FIRMWARE UPDATE INSTRUCTION + UPDATE HISTORY

BT-BLINDER2 IP

V1.08 (2022-03-07)

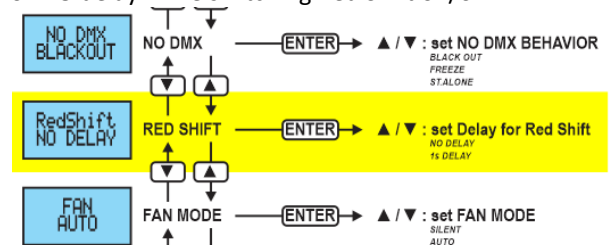
- This is an update to make sure that two different processor brands can be used during manufacturing, to overcome the current global shortage of electronic components.
